GoBike notes your proposal to consider introducing four traffic regulation orders for Canniesburn Toll roundabout, circulated to us by email on 2022-10-13.

1. CANNIESBURN TOLL ROUNDABOUT, BEARSDEN, PROPOSED WAITING AND LOADING RESTRICTION
2. CANNIESBURN TOLL ROUNDABOUT, BEARSDEN, PROPOSED RAISED TABLE, BUSINESS ACCESS ROAD
3. CANNIESBURN TOLL ROUNDABOUT, BEARSDEN, SHARED SURFACE (FOOTWAY/CYCLEWAY).
4. A739 SWITCHBACK ROAD, BEARSDEN. PROPOSED RELOCATION OF 40MPH SPEED LIMIT

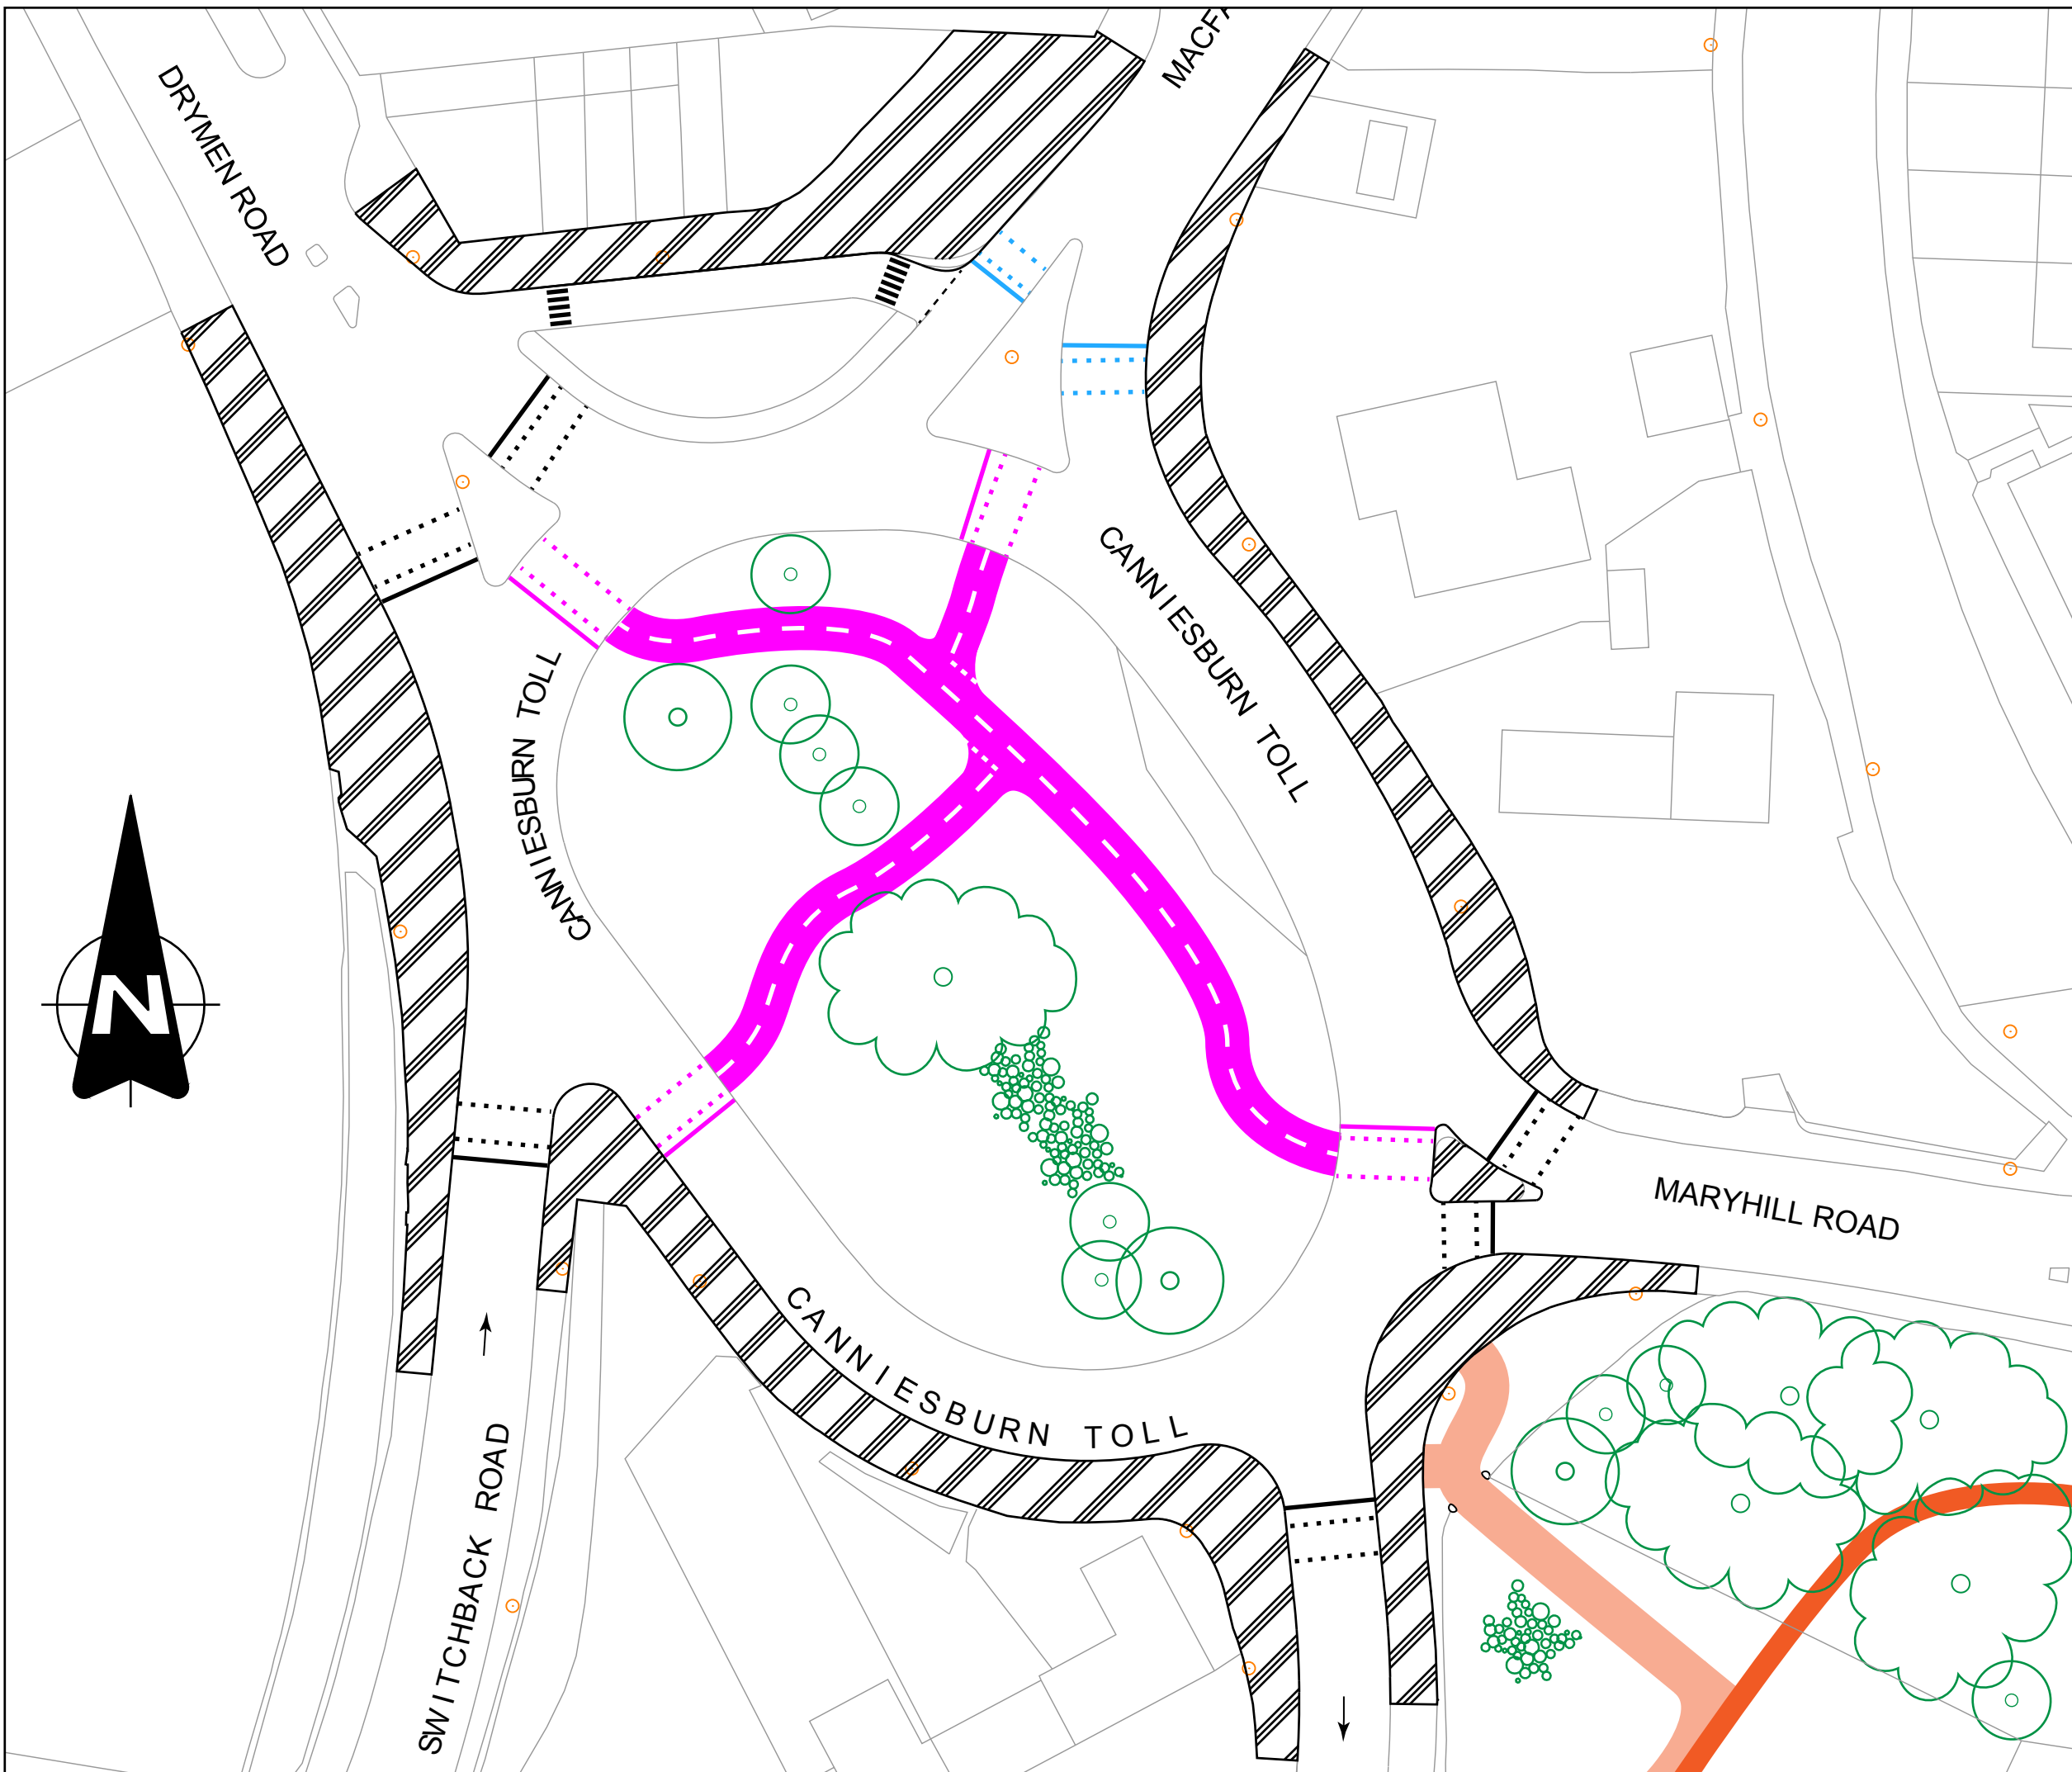
As discussed in our previous response, we believe more ambitious proposals would be relevant to this junction. GoBike's preferred layout would be similar to the Edmonton Green roundabout in Enfield, London. It has segregated cycletracks around the edge of the roundabout. There are bike lights next to traffic lights and each has their own phase (to avoid 'left hook' risk at each arm).

If the above is not possible, we would like to ask if cycle routes could be created through the centre of the toll to reduce interaction between people walking and cycling on shared-use spaces (and improve the experience for both). The following figure (p3) uses pink to illustrate the form that a separated route might take, where connection to an existing path (in orange) could be made via an opening in an existing wall to the south-east. This proposal has advantages in 1. activating dead space in the centre of the junction, 2. making use of sequenced phases in the signals which we believe are being proposed anyway, 3. improving *filtered permeability*, with 4. an option to extend access to Cluny Park/Bearsway and to the Garscube sports complex and Kelvin Walkway. It could further reduce severance effects and increase active travel access to the toll. It would also, to some extent, compensate for a lack of on-road cycling infrastructure nearby.
